Reviewed Revise and Resubmit
 Reviewed as Noted Rejected
 Not required by the Contract Documents
 For Record Only

RESERVE-BLDG E1
REVISED FRAMING PLAN
10152025

Job: QU03422_BUILD E1_RESERVE_10142025 - 1250435

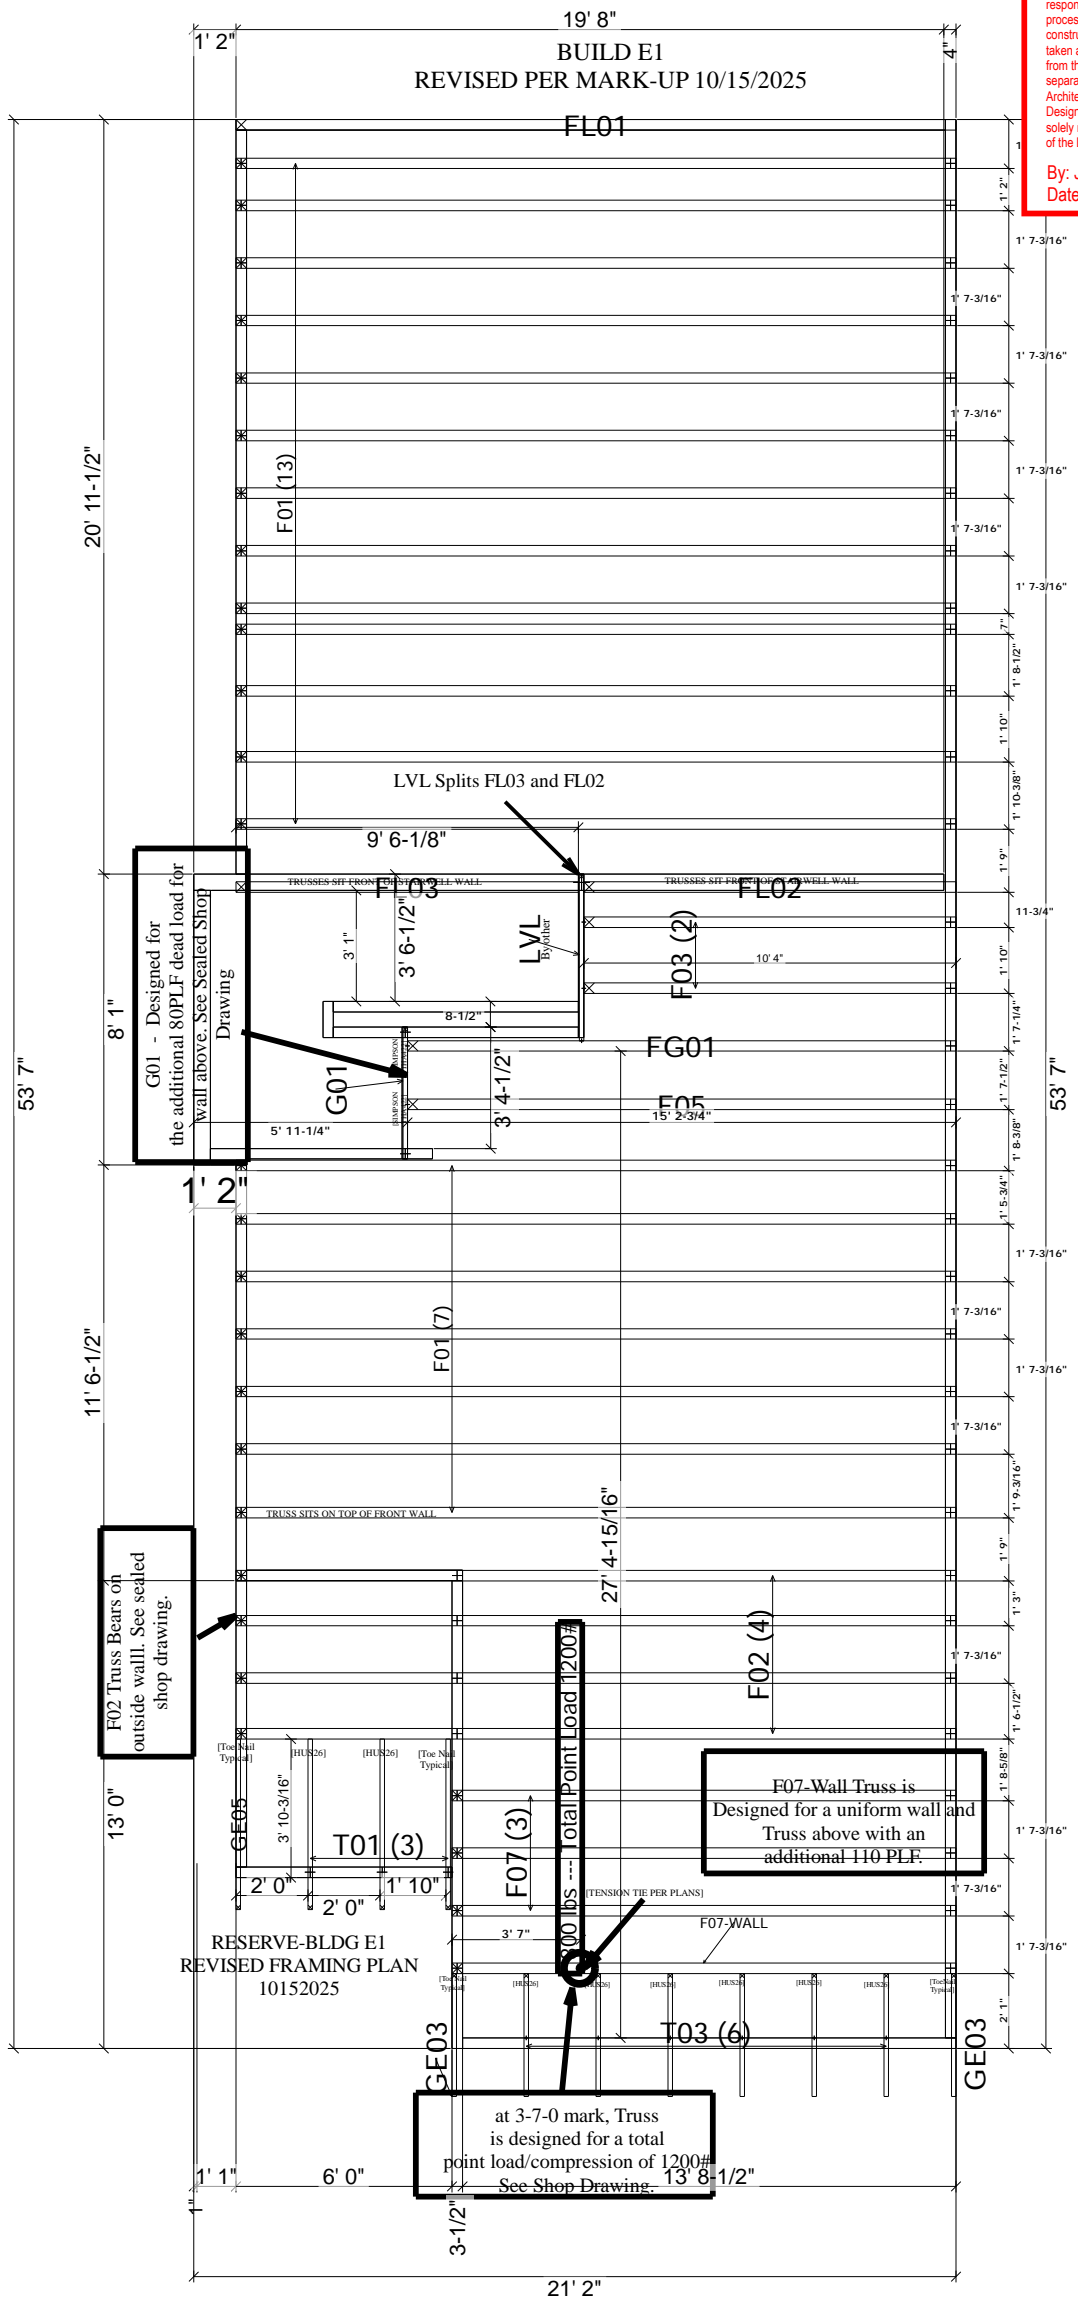
G01 - Designed for the additional 80PLF dead load for the wall above. See Sealed Shop Drawing.

F02 Truss Bears on outside wall. See sealed shop drawing.

F07-Wall Truss is Designed for a uniform wall and Truss above with an additional 110 PLF.

at 3-7-0 mark, Truss is designed for a total point load/compression of 1200# See Shop Drawing.
